World Forum for Harmonization of Vehicle Regulations**Working Party on Lighting and Light-Signalling****Eighty-third session**

UN Regulation No. 48 (Installation of lighting and light-signalling devices):**Proposals for new series of amendments to UN Regulation No. 48****Proposal for a Supplement to the 06 and 07 series of amendments to UN Regulation No. 48****Submitted by the expert from the International Organization of Motor Vehicle Manufacturers***

The text reproduced below was prepared by the expert from the International Organization of Motor Vehicle Manufacturers (OICA). This proposal intends to improve the requirements linked to the manual levelling device. The modifications to the existing text are marked in bold for new or strikethrough for deleted characters.

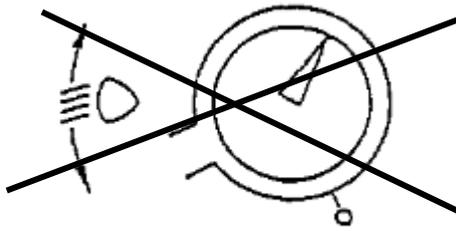
1. Specifications
 - 1.1. ~~Downward~~Inclination of the dipped-beam shall in all cases be produced **by a simple control, the operation of which is clearly described in the owner's handbook.** ~~in one of the following ways:~~
 - ~~(a) by moving a control downwards or to the left;~~
 - ~~(b) by rotating a control in a counter clockwise direction;~~
 - ~~(c) by depressing a button (push-pull control).~~

A rotary control that is installed edge on, or with only the edge visible, should follow the operating principles of control of types (a) or (c).
 - 1.1.1. This control shall carry symbol(s) indicating clearly the movements corresponding to the downward and upward inclination of the dipped beam.
 - 1.2. The "0" position corresponds to the initial inclination according to paragraph 6.2.6.1.1. of this Regulation.
 - 1.3. [The marks used on control shall be explained in the owner's handbook.]
 - 1.4. ~~Only the following symbols may be used to identify the controls:~~

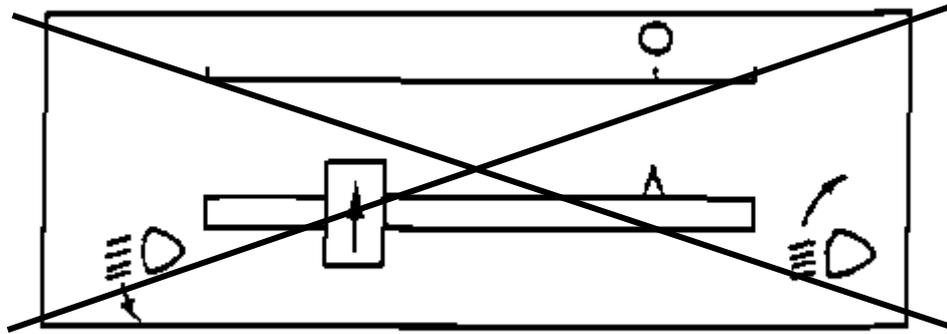
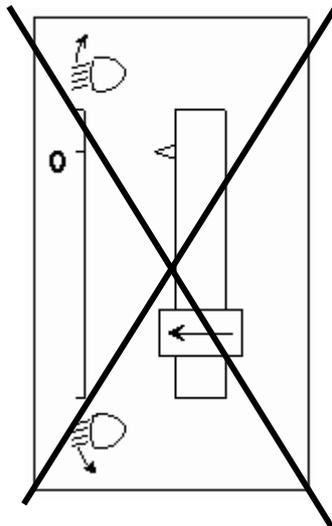
8. 'Downward' should be deleted. In the old text it referring to the direction of the control device. For trucks we are adjusting the dipped beam both upwards and downwards due to different loading characteristics of different vehicle configurations.
 9. In order for the requirements to be technology neutral, the prescription of control methods (downwards, rotary, push-pull) have been deleted.
 10. Requirement 1.3 referring to the owner's handbook has been moved into the main regulatory text (see paragraph 6.2.6.2.2.5.) and therefore can be deleted.
 11. Requirement 1.4. specifying the symbols, which can be used, has been deleted as these are already prescribed in UN Regulation No. 121.
 12. Examples of controls 1, 2 and 3 have been deleted as the illustrations are considered outdated.
-
